SUNDRY NOTICES AND REPORTS ON WELLS

8. Well Name and No.
BURCH KEELY UNIT 8

9. API Well No.
30-015-20564-00-S1

**** BLM REVISED ** BLM REVISED ** BLM REVISED ** BLM REVISED ** BLM REVISED ****

Lease & Well # **Burch Keely Unit 8**

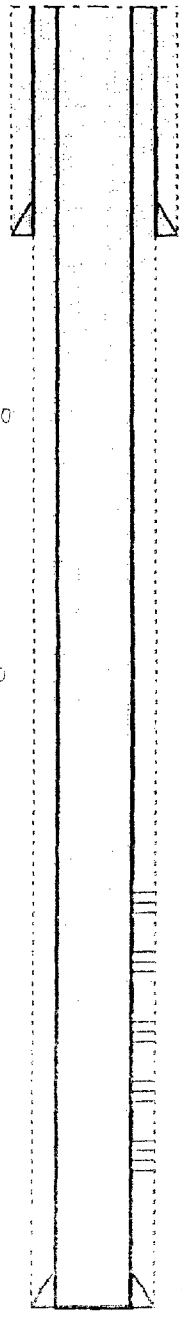
1. Set 4 1/2" CIBP @ 2480', Circulate hole w/ MLF. Pressure test csg. Spot 30 sx cmt @ 2480~~-2000'~~ 1986 (SA/Qu)
2. Perf & Sqz 25 sx cmt @ 1050~~-900'~~ WOC & Tag (B/Salt) 875
3. Perf & Sqz 25 sx cmt @ 547-300'. WOC & Tag (8 5/8" Shoe)
4. Perf & Sqz 25 sx cmt @ 150'-Surface.
5. Cut off well head, verify cmt to surface, weld on Below Ground Dry Hole Marker.

Below ground level dry hole marker required
